Docket Nos.: 52-025
52-026

Southern Nuclear Operating Company
Vogtle Electric Generating Plant Units 3 and 4
Request for License Amendment and Exemption:
Tier 1 and Tier 2* Editorial and Consistency Changes (LAR-17-042)

**Vogtle Electric Generating Plant (VEGP) Units 3 and 4
Proposed Changes to the Licensing Basis Documents
(LAR-17-042)**

COL Appendix C (and associated plant-specific Tier 1) Figure 2.3.2-1 “Chemical and Volume System”

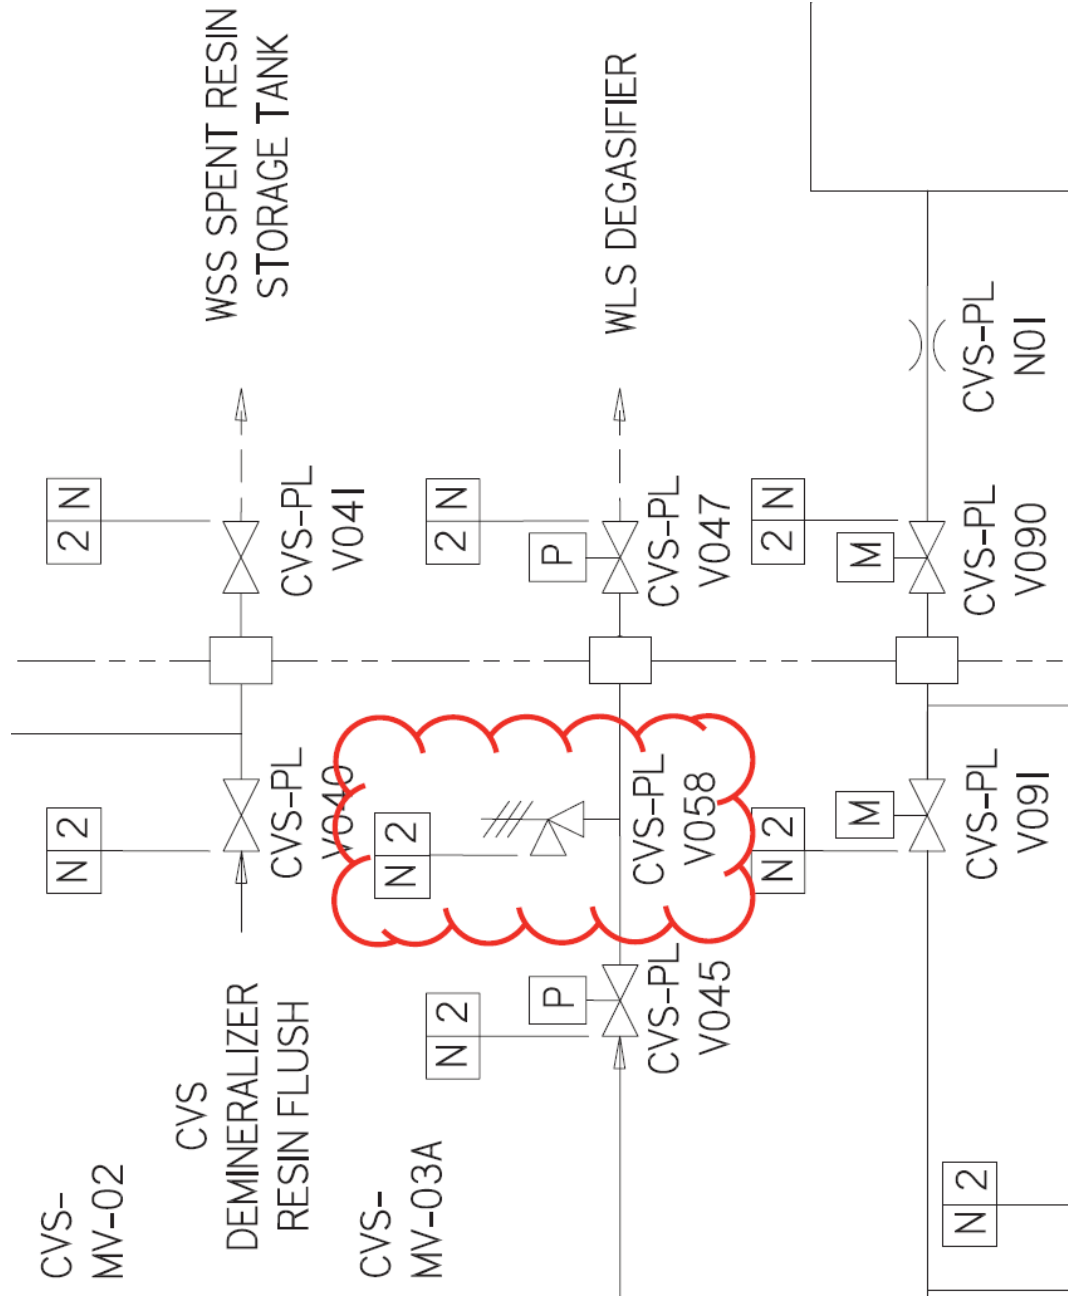
This valve is included in COL Appendix C Figure 2.2.1-1 and Table 2.3.2-1 and in UFSAR Table 3.2-3 and Figure 9.3.6-1 but it was not included in the depiction of the CVS in COL Appendix C Figure 2.3.2-1. Therefore, this valve is added to COL Appendix C Figure 2.3.3-1 for consistency with other Figures and Tables in COL Appendix C and the UFSAR.

- Figure 2.3.2-1 adds relief valve CVS-PL-V058 to the related CVS piping.
- Subsection 2.3.6, design commitment 13, replaces "listed function" with "control function."

- Tier 1 Figure 2.3.2-1 adds relief valve CVS-PL-V058 to the related CVS piping.
- Tier 1 Subsection 2.3.6, design commitment 13, replaces “listed function” with “control function.”

COL Appendix C (and associated plant-specific Tier 1) Figure 2.7.2-1 (Sheet 1) "Central Chilled Water System"

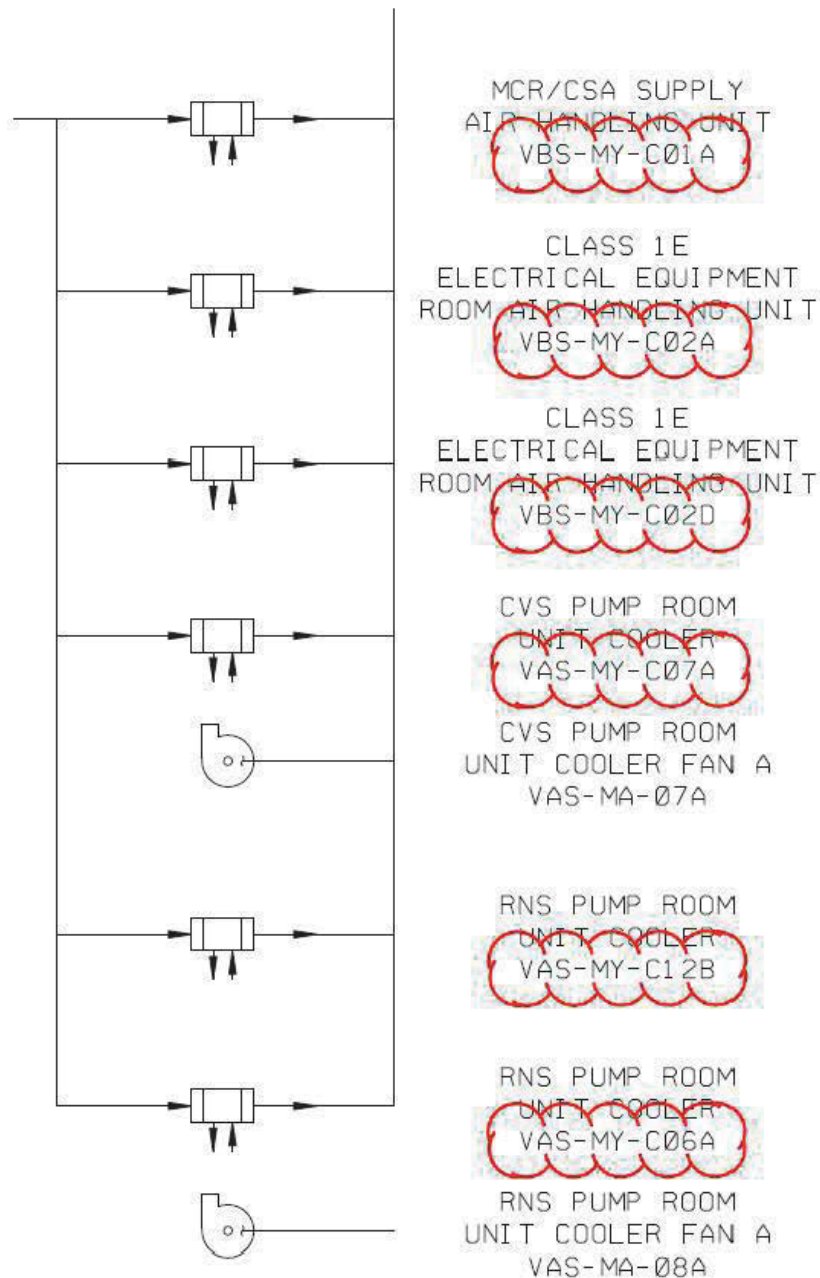
The low capacity VWS supports the defense-in-depth function of providing chilled water to the RNS pump room unit coolers in the event that heat must be rejected from this room. COL Appendix C Figure 2.7.2-1 and UFSAR Figure 9.2.7-1 show the chiller pump VWS-MP-02 as providing water to the RNS pump room unit cooling coil, VAS-MY-C12A, and chiller pump, VWS-MP-03, as providing water to the RNS pump room unit cooling coil, VAS-MY-C12B. The tag numbers of the pump room unit cooling coils have been reversed and are changed because chiller pump, VWS-MP-02, provides water to the RNS pump room unit cooling coil, VAS-MY-C12B, and chiller pump, VWS-MP-03, provides water to the RNS pump room unit cooling coil, VAS-MY-C12A.

Additionally, an editorial change is required for the tag numbers of components identified in COL Appendix C Figure 2.7.2-1 (Sheets 1 and 2). This figure identifies cooling coils which use a different tag numbering convention than in COL Appendix C Table 2.7.2-2 and in UFSAR Figure 9.2.7-1. It is proposed to change the COL Appendix C Figure 2.7.2-1 tag numbers as identified below.

Figure 2.7.2-1 Tag Number	Proposed Change
VBS-MYC-01A/B	VBS-MY-C01A/B
VBS-MYC-02A/B	VBS-MY-C02A/B
VBS-MYC-02C/D	VBS-MY-C02C/D
VAS-MYC-07A/B	VAS-MY-C07A/B
VAS-MYC-12A/B	VAS-MY-C12A/B
VAS-MYC-06A/B	VAS-MY-C06A/B

- Table 2.7.1-2 changes the title of WWS-PL-L851 to “Main Control Room Waste Water Line”.
- Figure 2.7.2-1 (Sheet 1) changes chiller pump, VWS-MP-02, to provide water to the RNS pump room unit cooling coil, VAS-MY-C12B.

- Figure 2.7.2-1 (Sheet 1) changes the tag number convention of cooling coils from VAS/VBS-MYC-xxx to VAS/VBS-MY-Cxxx.
- Figure 2.7.2-1 (Sheet 2) changes chiller pump, VWS-MP-03, to provide water to the RNS pump room unit cooling coil, VAS-MY-C12A.

- Tier 1 Figure 2.7.2-1 (Sheet 1):
 - Changes chiller pump, VWS-MP-02, to provide water to the RNS pump room unit cooling coil, VAS-MY-C12B.
 - Changes the tag number convention of cooling coils from VAS/VBS-MYC-xxx to VAS/VBS-MY-Cxxx.

Figure 2.7.2-1 (Sheet 1) - Revise the tag number for the RNS Pump Room Unit Cooler and the coiling coils, as shown below.

COL Appendix C (and associated plant-specific Tier 1) Figure 2.7.2-1 (Sheet 2) "Central Chilled Water System"

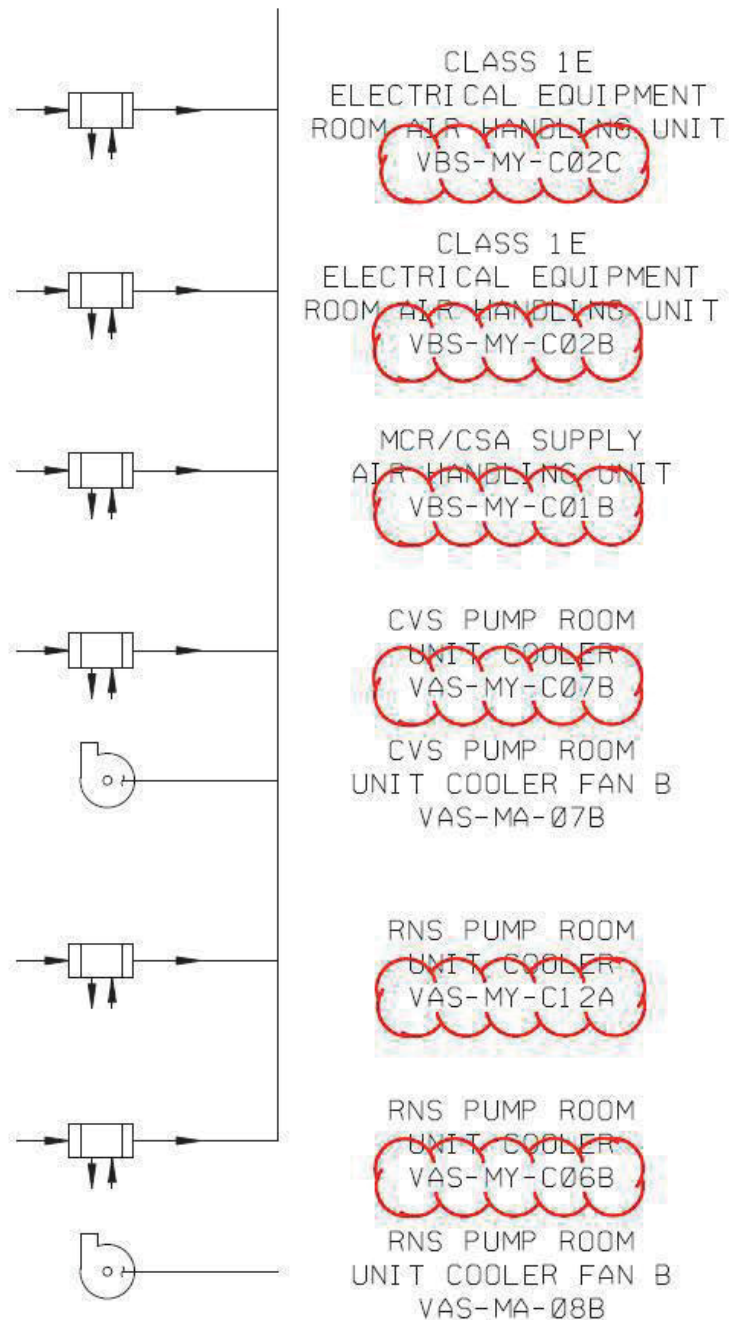
- Figure 2.7.2-1 (Sheet 2) changes the tag number convention of cooling coils from VAS/VBS-MYC-xxx to VAS/VBS-MY-Cxxx.
- Table 3.5-1 is updated to show the MCR supply air radiation monitoring packages A and B as included with the PMS safety-related displays.

- Tier 1 Figure 2.7.2-1 (Sheet 2)
 - Changes chiller pump, VWS-MP-03, to provide water to the RNS pump room unit cooling coil, VAS-MY-C12A.
 - Changes the tag number convention of cooling coils from VAS/VBS-MYC-xxx to VAS/VBS-MY-Cxxx.

Figure 2.7.2-1 (Sheet 2) - Revise the tag number for the RNS Pump Room Unit Cooler and the coiling coils, as shown below.

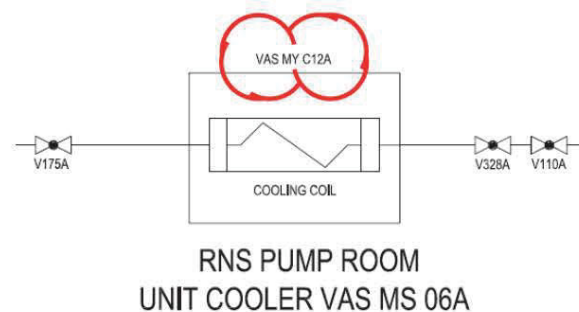
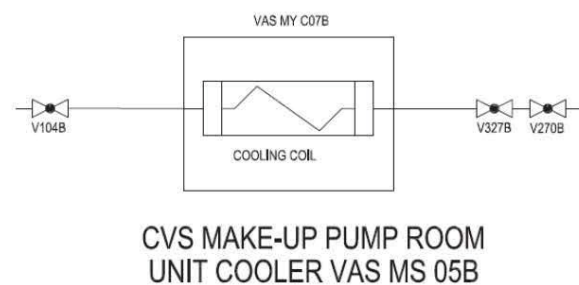
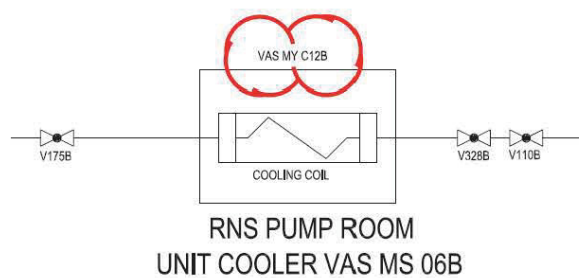
- Table 6.2.3-1 is updated to differentiate between the upper personnel hatch and the lower personnel hatch.
- Table 7.5-1 is revised to show MCR supply air radiation as included in the QDPS indications.

Table 6.2.3-1– Correct the descriptions of the Personnel Hatches, as shown below.

UFSAR Figure 9.2.7-1 (Sheet 2) “Simplified Central Chilled Water System Piping and Instrumentation Diagram (REF) VWS 007”

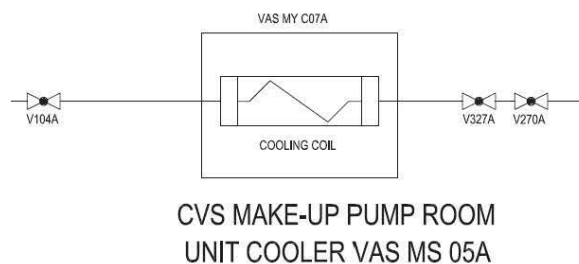
- Figure 9.2.7-1 changes chiller pump, VWS-MP-02, to provide water to the RNS pump room unit cooling coil, VAS-MY-C12B.
- Figure 9.2.7-1 changes chiller pump, VWS-MP-03, to provide water to the RNS pump room unit cooling coil, VAS-MY-C12A.

Figure 9.2.7-1 - Revise the tag number for the RNS Pump Room Unit Coolers, as shown in the two depictions below.
